**HIGHLAND UNITED NEIGHBORS, INC., COMMENTS ON:**

*(1) DENVERIGHT COMPREHENSIVE PLAN 2040, (2) DENVERIGHT BLUEPRINT DENVER*

*November 28, 2018*

### Growth Areas

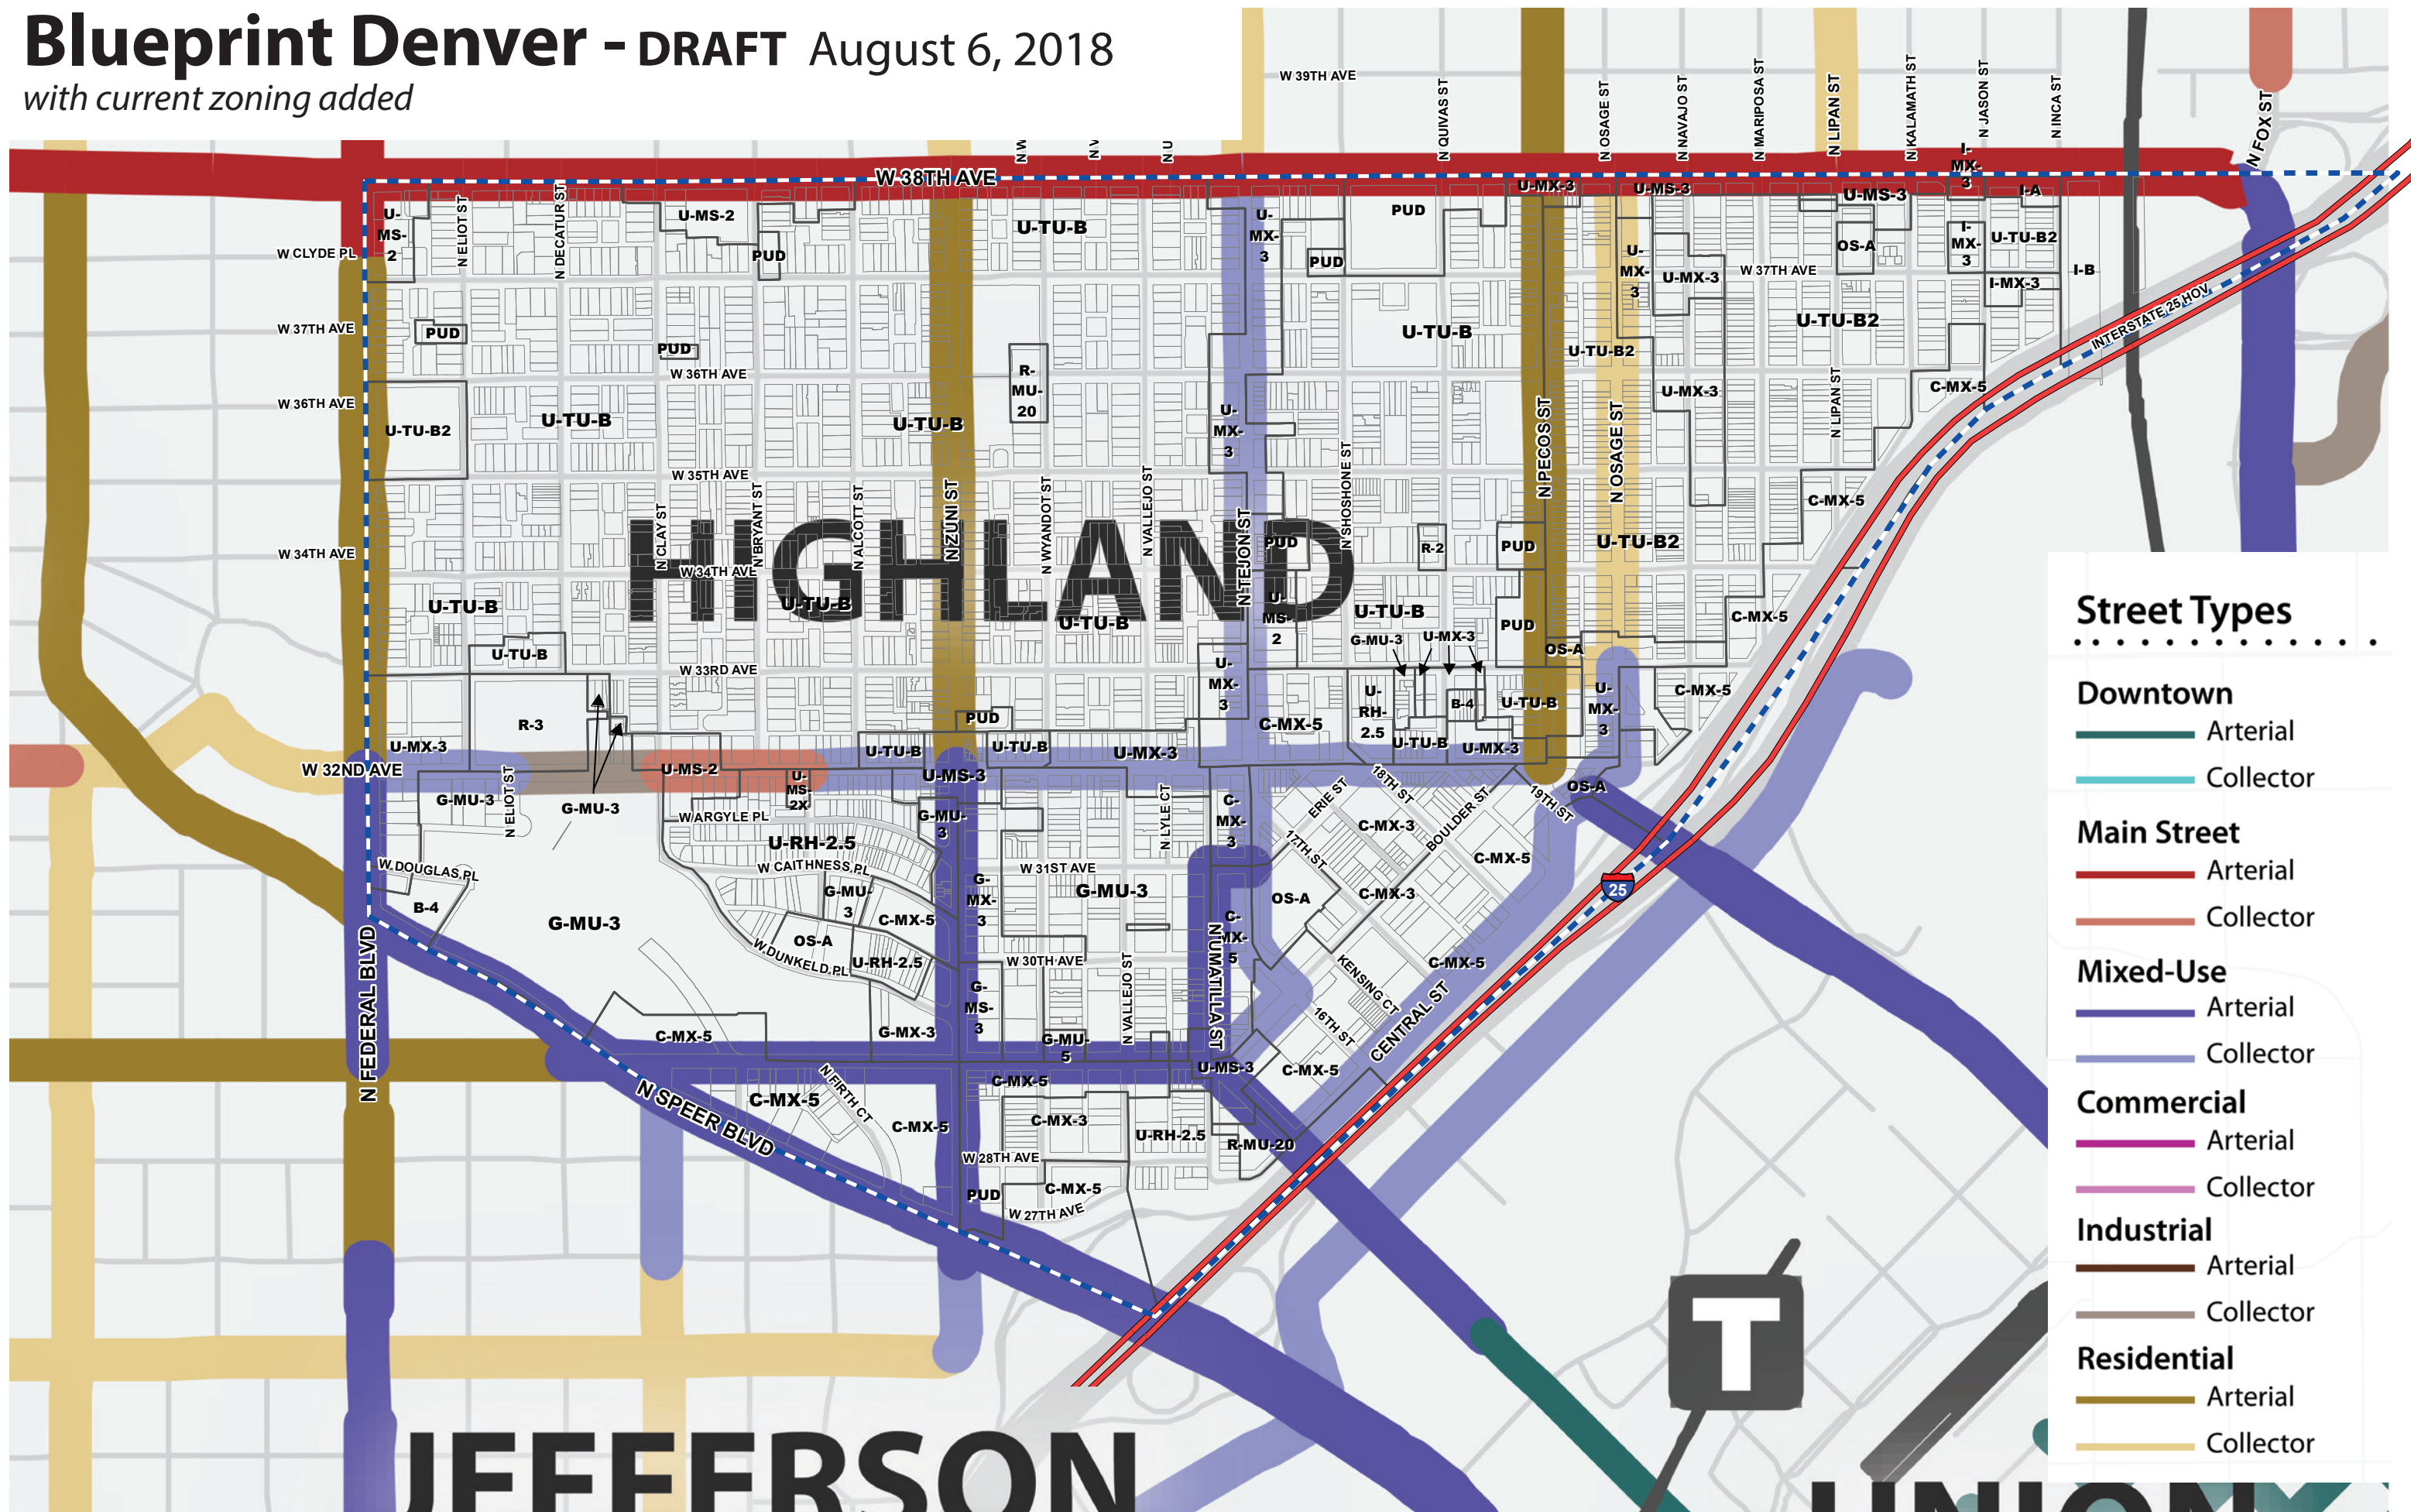
14	<b>GROWTH AREAS MAP</b>	The various shades of blue are very difficult to discern.	<i>The shades of blue are very difficult to differentiate, and colors on the map do not precisely match the colors on the key. We request that the colors be adjusted for improved clarity. SEE FOLLOWING ITEMS FOR SPECIFIC RECOMMENDATIONS.</i>
15	Growth Areas Map	Significant areas of future growth are shown in areas that have already been redeveloped since the new zoning code was adopted in 2010.	Significant areas of future growth are shown in areas that have already been redeveloped since the new zoning code was adopted in 2010. Our request is to change the map to show High and Medium-High Intensity Residential areas ONLY where opportunities still exist in the Highland Neighborhood. We see this as only possible in C-MX-5 Districts where redevelopment has not been completed in recent years. SEE HUNI GROWTH AREAS MAP.

16	Growth Area Map	Public Parks are shown as “Certain Districts” and “High and Medium-High Residential” areas.	Public Parks are shown as if they can be redeveloped for residential and commercial uses on this map. We believe this map can only be representative of potential growth if it excludes parkland, and clearly identifies it as Open Space. Our request it to map Open Space to make this clear for Viking Park, Hirshorn Park, Highland Gateway Park, Community Plaza Park, St. Patrick’s Neighborhood Park, Franco Park, and City of Cuernavaca Park. This should be changed city-wide. SEE HUNI GROWTH AREAS MAP.
17	<b>STREET TYPES MAP</b>	Street Types—There are too many street types shown in Highland.	<i>In general, this map shows a wide variety of street types that don’t capture a consistent approach to the public realm. It also assigns incorrect designations to several streets. Our goal is to create a consistent public realm that aligns with the predominant characteristics that make Highland a desirable place to live and visit. SEE HUNI STREET TYPES MAP and specific descriptions of street types requiring modifications that follow:</i>

# HUNI - RECOMMENDATIONS November 28, 2018

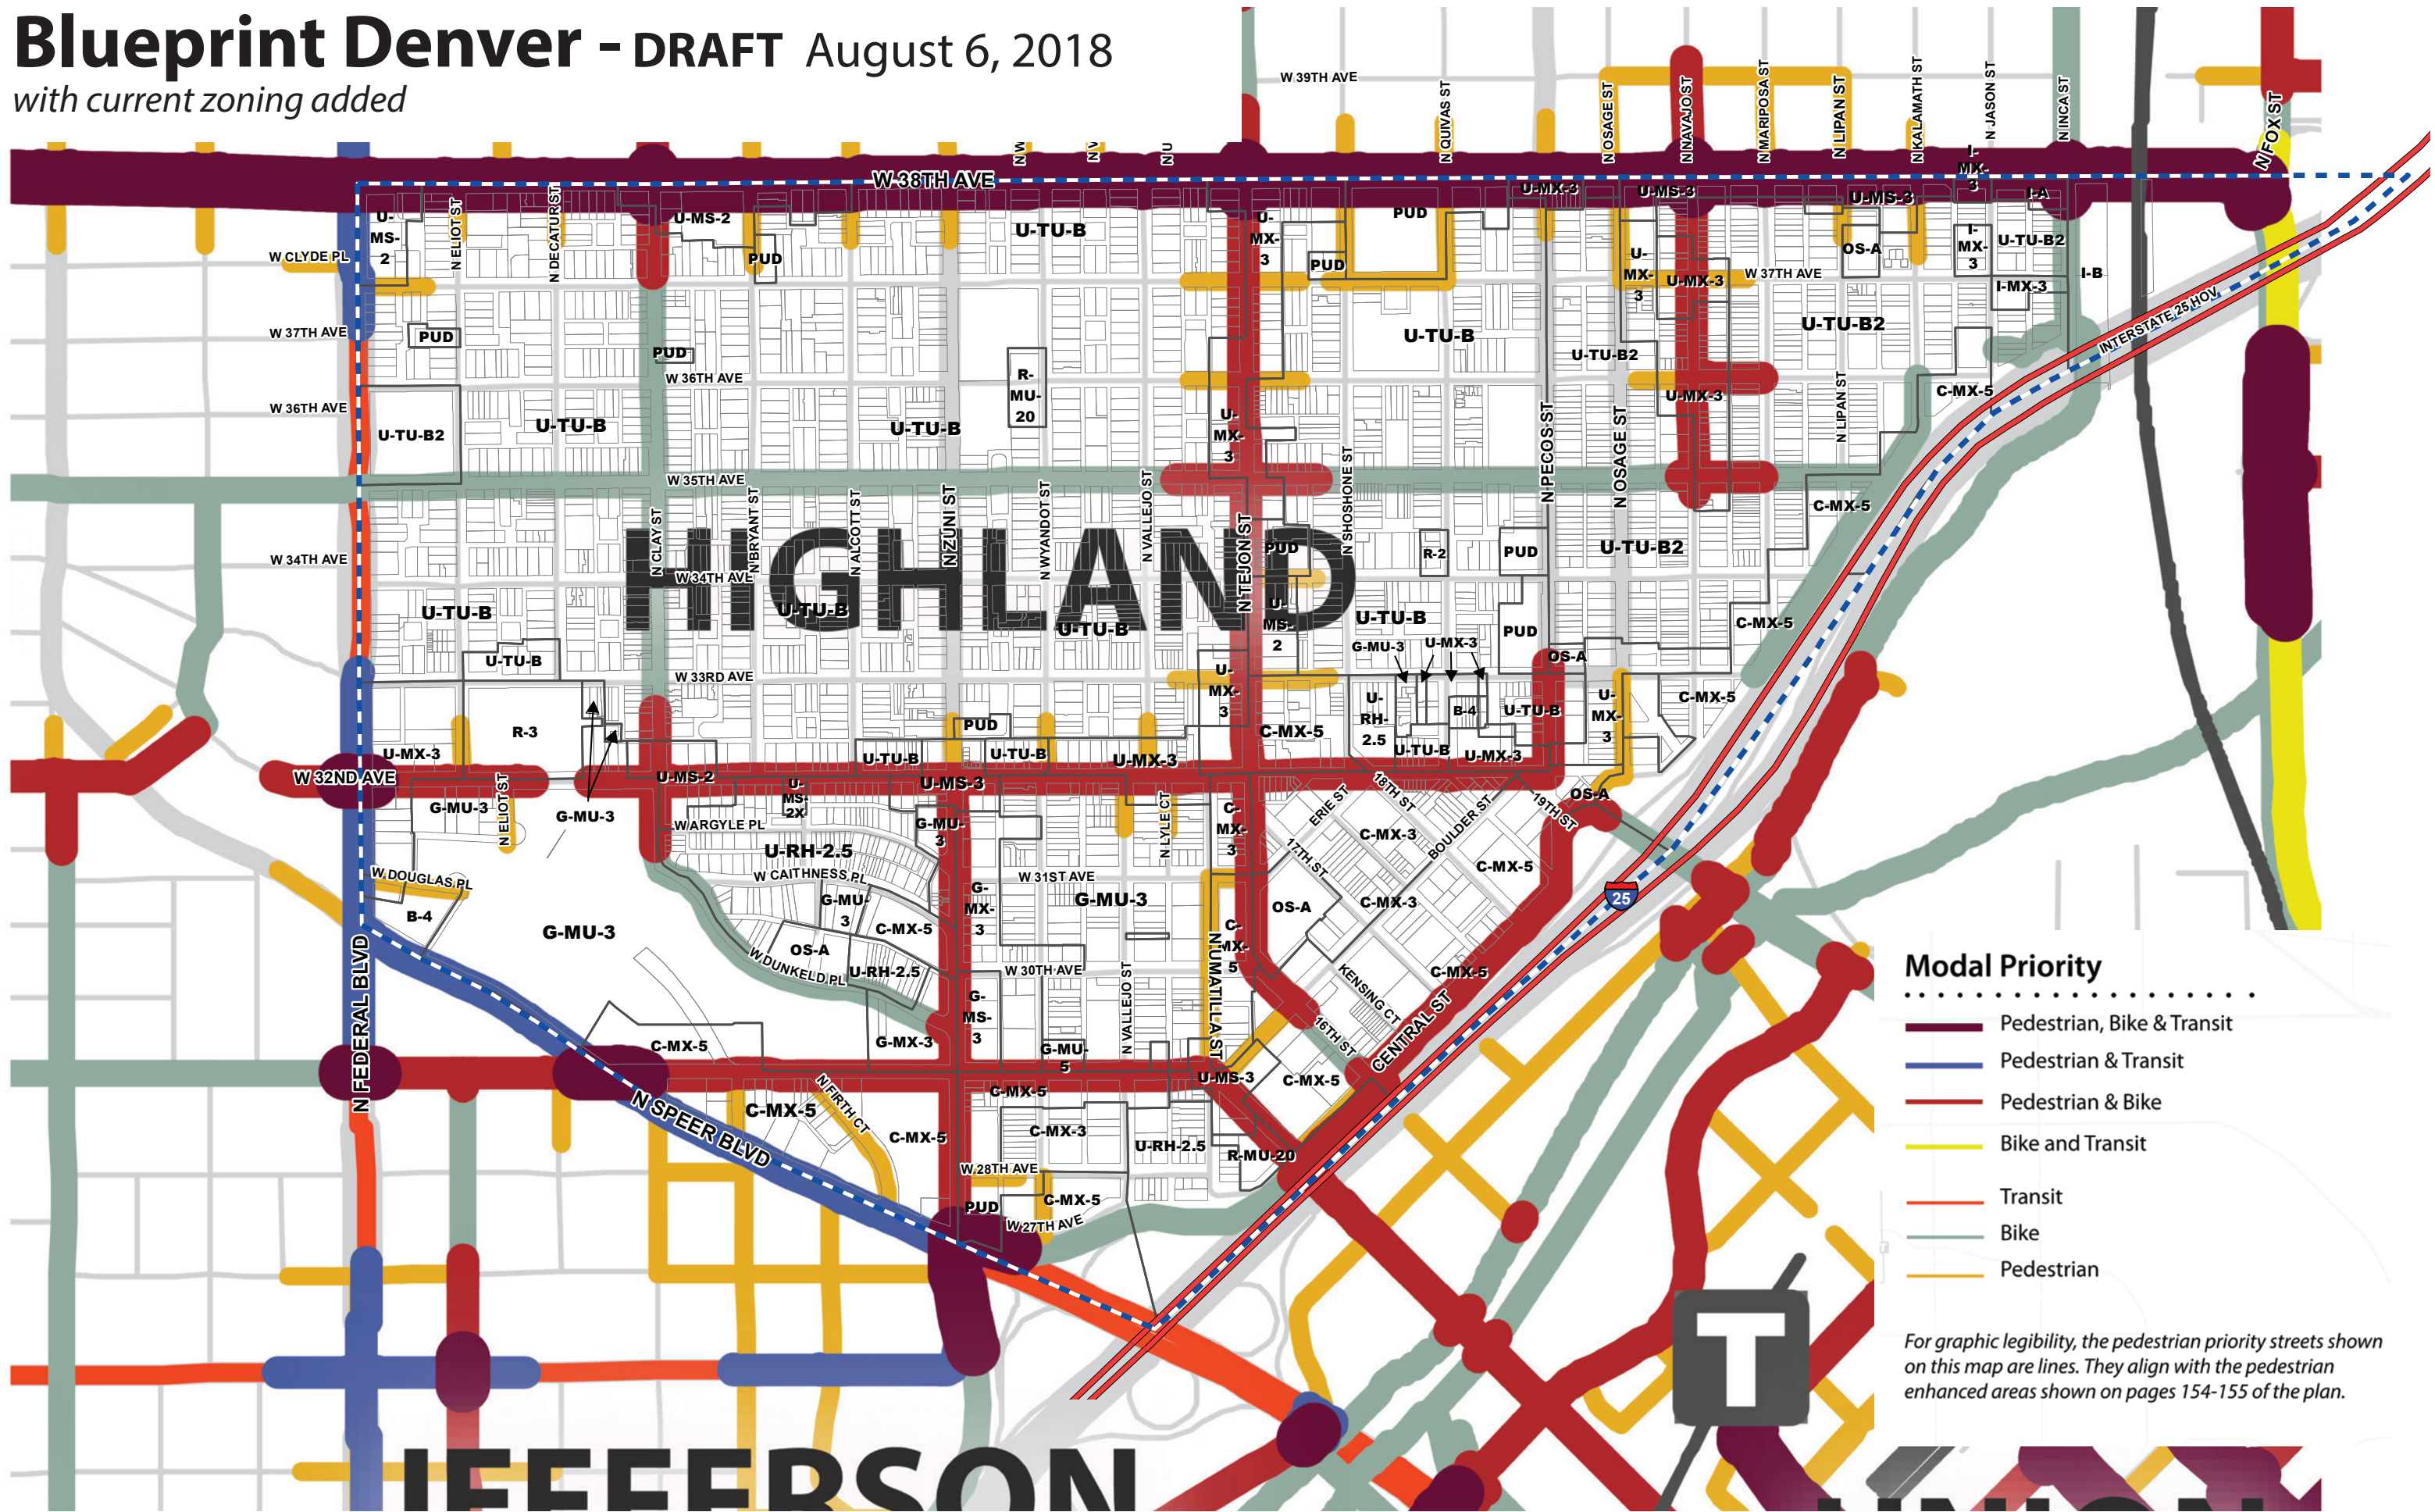
18	Street Types Map	Street Types do not include Parkways. Two of Highland's boundaries are Parkways.	Federal Boulevard and Speer Boulevard are the west and south boundaries of the Highland Neighborhood. They are shown on the map as Commercial Arterial, Residential Arterial, and Mixed-Use Arterial, depending on location. Since each street type has different Public Realm designs, we believe that a consistent approach is needed for both designated Parkways, and that the Parkway designation deserves its own category to align with City requirements. Our request is to change this map to add a Parkway street type along with appropriate design criteria. SEE HUNI STREET TYPES MAP.
19	Street Types Map	West 32 <sup>nd</sup> Avenue has four different street types between Highland Park and Zuni Street.	West 32 <sup>nd</sup> Avenue has four different street type designations from Highland Park to Highland Gateway Park. We believe that a single street type would bring consistency to the public realm throughout our neighborhood. Given the numerous residences, multi-family residential buildings, and mixed use buildings (ground floor commercial, upper floors residential), we believe the Residential Collector designation would be the most appropriate, as it maintains tree lawns at residential uses. We request that a single designation of Residential Collector be shown on the map for the entire length of West 32 <sup>nd</sup> Avenue in Highland. SEE HUNI STREET TYPES MAP.

20	Street Types Map	Zuni Street and West 29 <sup>th</sup> Avenue have multiple street types shown and in some areas the map doesn't recognize the primarily residential uses in existence.	Zuni Street and West 29 <sup>th</sup> Avenue have multiple street types shown and in some areas the map doesn't recognize the primarily residential uses in existence. We agree that both streets function as Arterials, due to the amount of through-traffic from other neighborhood funneling through Highland connecting the Downtown and I-25. However, we believe the Residential Arterial designation fits better with the primarily residential nature of these streets. We request that the Residential Arterial designation be shown on the map for the entire length of these streets in Highland. SEE HUNI STREET TYPES MAP.
21	Street Types Map	Tejon Street is shown as a Mixed-Use Street Type; it is a primarily Residential street north of 32 <sup>nd</sup> Avenue.	Tejon Street is a primarily residential street north of West 32 <sup>nd</sup> Avenue, so we believe that the designation should be changed to Residential Collector. This will preserve the ROW streetscape of tree lawns at residential properties. We request that the Residential Collector designation be shown on the map between 32 <sup>nd</sup> Avenue and 38 <sup>th</sup> Avenue. SEE HUNI STREET TYPES MAP.

22	Street Types Map	Umatilla Street is shown as a Mixed-Use Arterial between 29 <sup>th</sup> Avenue and 31 <sup>st</sup> Avenue; it is a narrow residential street and does not serve as a Collector, not to mention an Arterial.	Umatilla Street is a narrow local street serving primarily residential uses. It is neither a Collector nor an Arterial street. We request that the map be changed from Mixed-use Arterial to Local Street. SEE HUNI STREET TYPES MAP.

23	Street Types Map	16 <sup>th</sup> Street between Central and Boulder Streets is not shown with any designation beyond local street.	16th Street between Central and Boulder Streets is not shown with any designation beyond local street. It clearly acts as a Mixed-Use Collector, continuing from the south end of Tejon Street and connecting to Central Street, another Mixed-Use Collector. We request that the map be changed from Local to Mixed-Us Collector. SEE HUNI STREET TYPES MAP.
24	Street Types Map	The trio of Pecos, Osage, and Navajo Streets, which work together at a local level while connecting through traffic between 38 <sup>th</sup> Avenue and 20 <sup>th</sup> Street, are shown incorrectly.	The trio of Pecos, Osage, and Navajo Streets, which work together at a local level while connecting through traffic between 38th Avenue and 20th Street, are shown incorrectly. Pecos serves as a Residential Collector. Osage is narrower, and serves as a local street north of 33 <sup>rd</sup> Avenue. Navajo also serves as a Residential Collector. We request that the map be changed to show Pecos and Navajo as Residential Collectors and to show Osage as a local street north of 33 <sup>rd</sup> Avenue. SEE HUNI STREET TYPES MAP.
